CITY OF PLACERVILLE PUBLIC WORKS

CONTRACT CHANGE ORDER MEMORANDUM

Western Placerville Interchanges Phase 1B

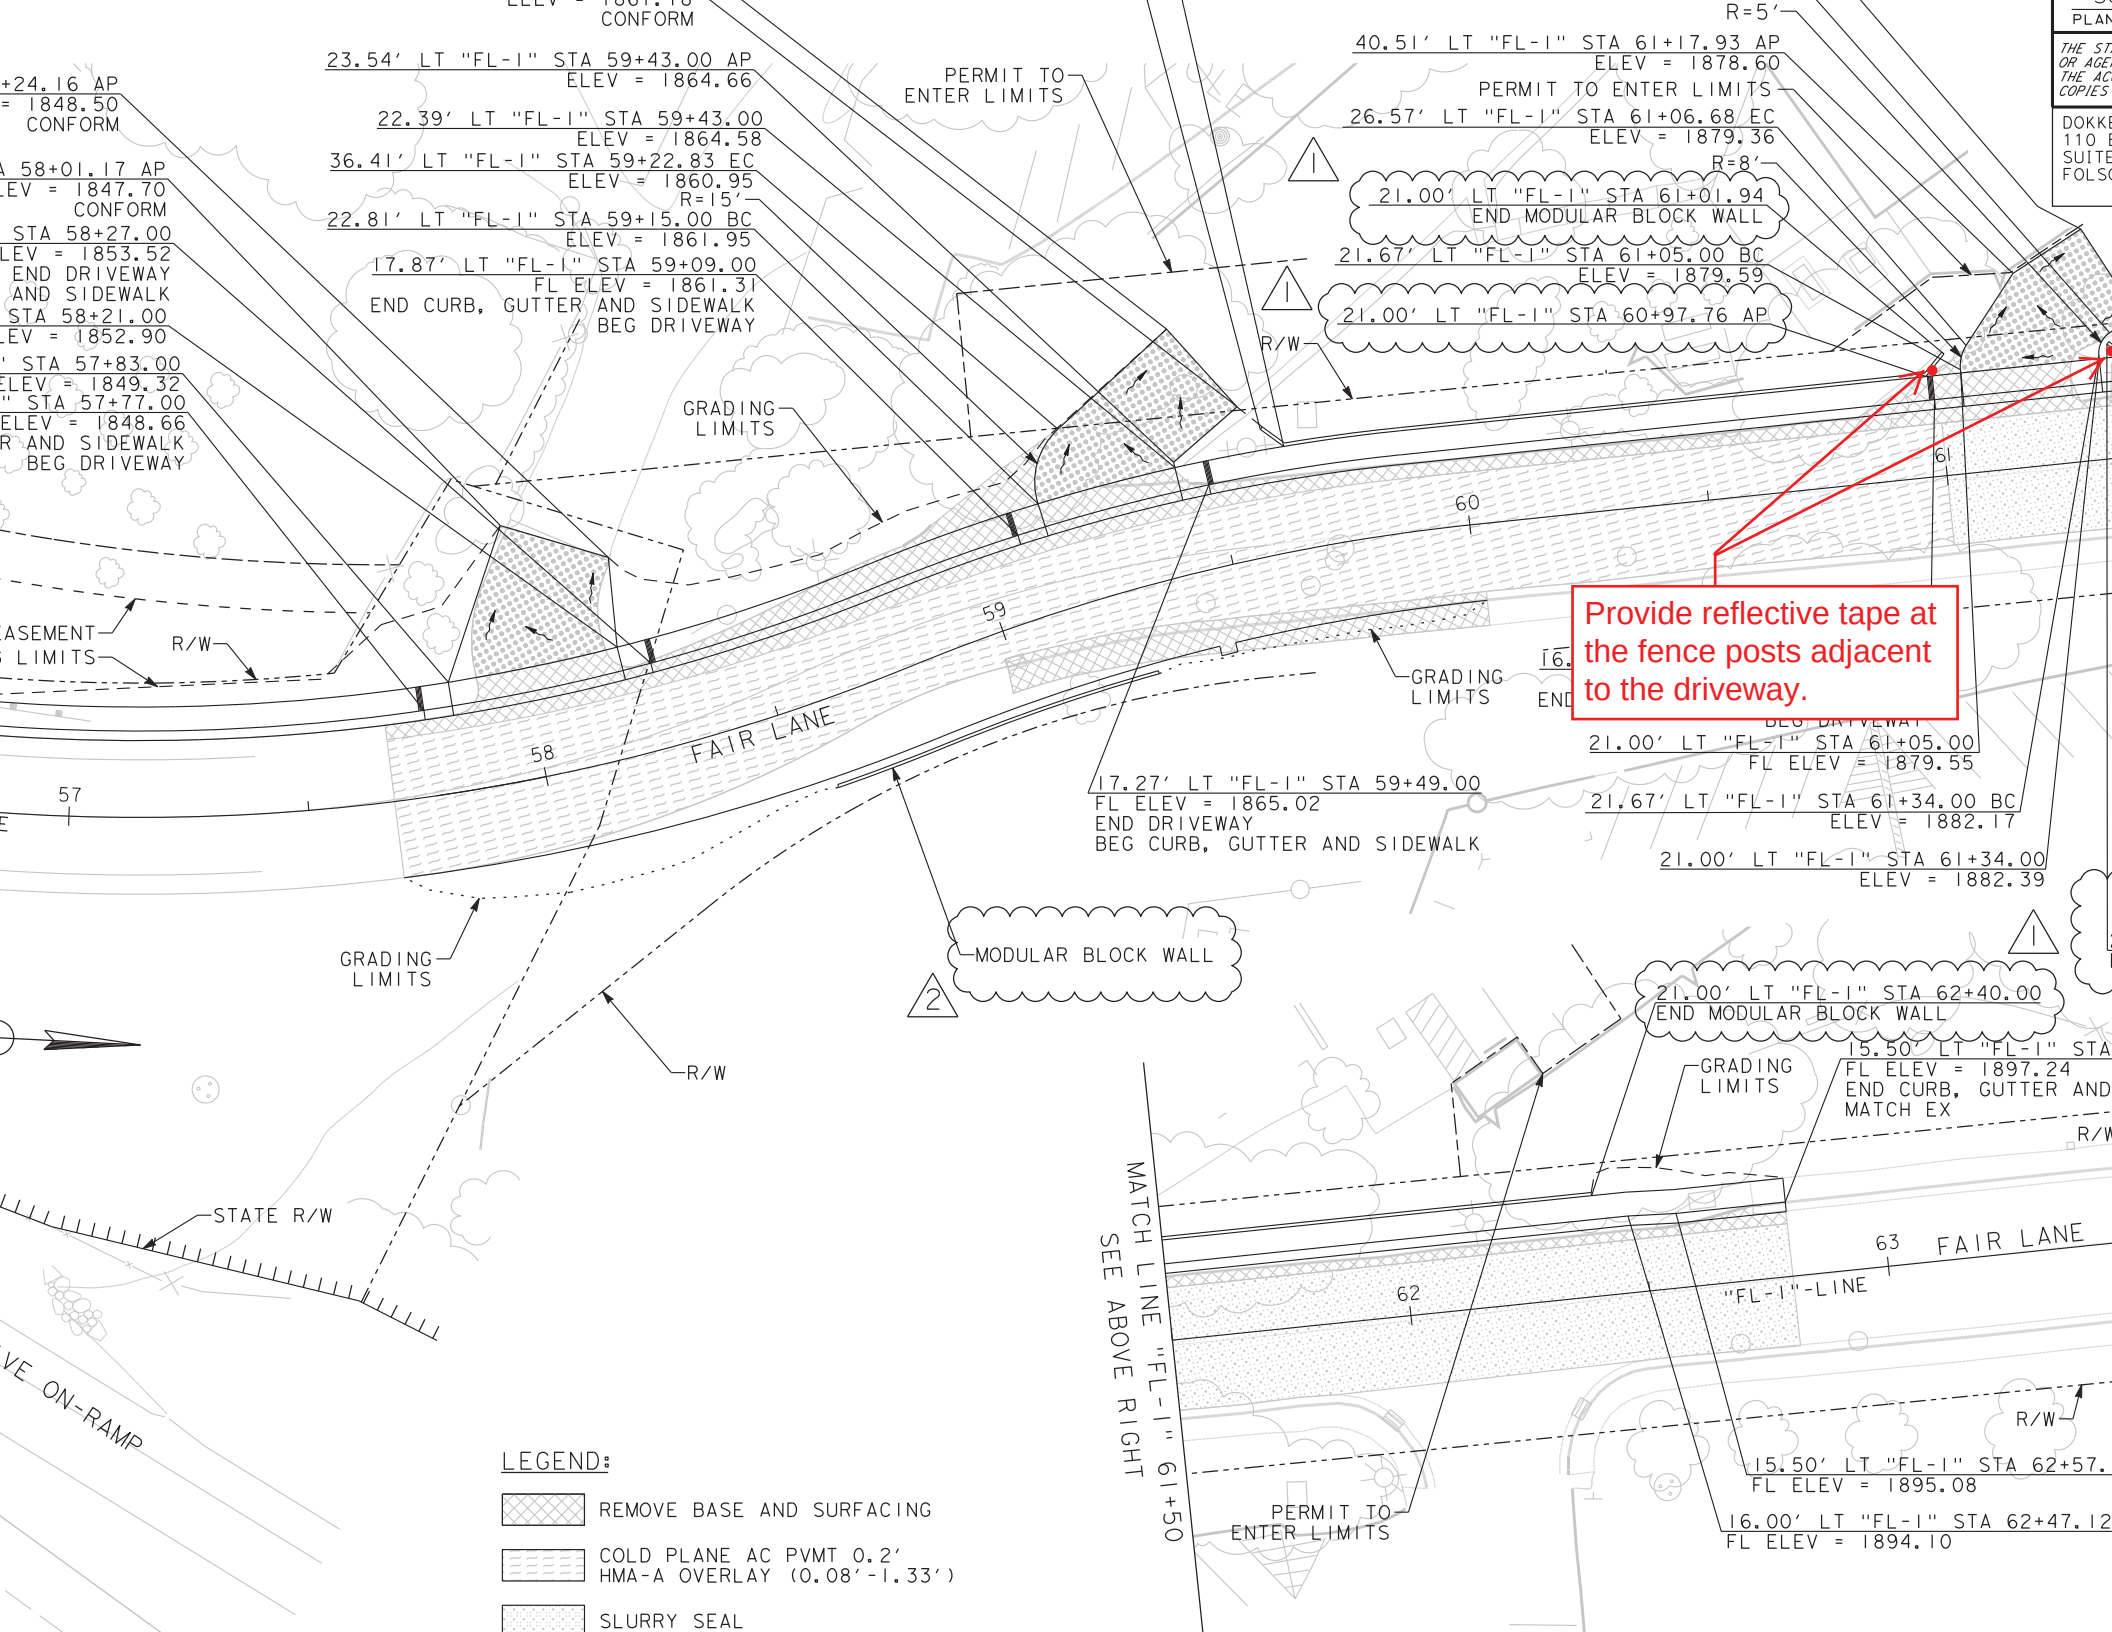
Plan Sheet No. 9 & 11S1 showing comments, in red, the approximate location of reflective tape to be installed on the fence poles.
Cost Breakdown of Field Change Directive.

17.27' LT "FL-1" STA 59+49.00
FL ELEV = 1865.02
END DRIVEWAY
BEG CURB, GUTTER AND SIDEWALK
Provide reflective tape at the fence posts adjacent to the driveway.

Install 3 - 2" White Reflective Tape Strips and wrap around pole to ensure visibility from all directions.

Provide 12" gap from the top of the pole and place tape 12" on center.

Field Change #8 - Exhibit

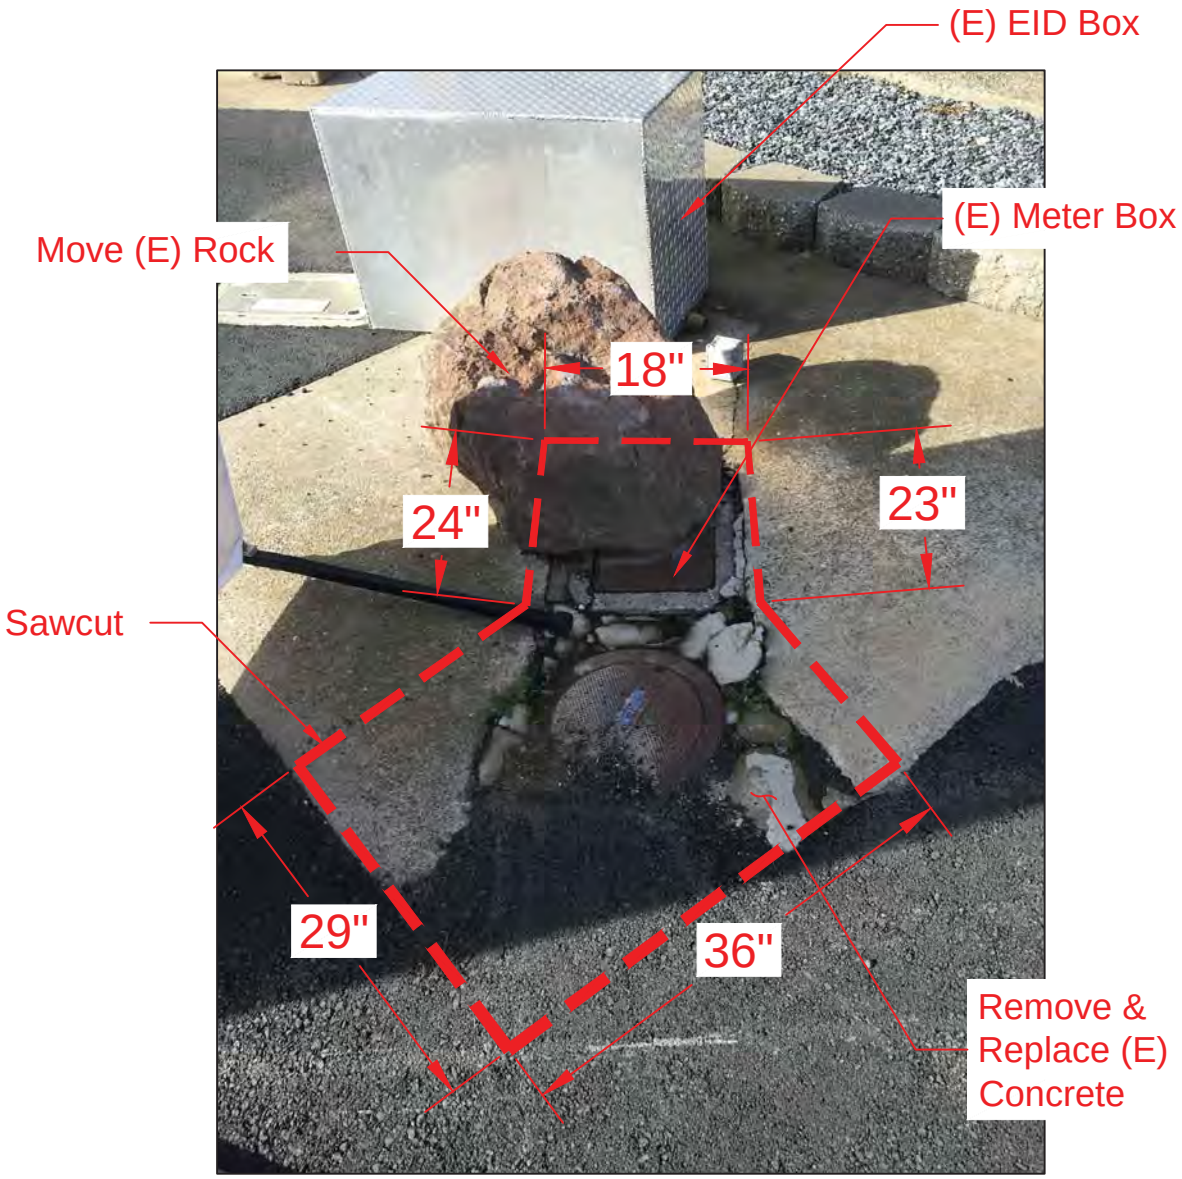
Remove & Replace the existing broken concrete around the meter box in front of Vintage Transport.

Field Change Directive #8 Exhibit.
Cost Breakdown of Field Change Directive.
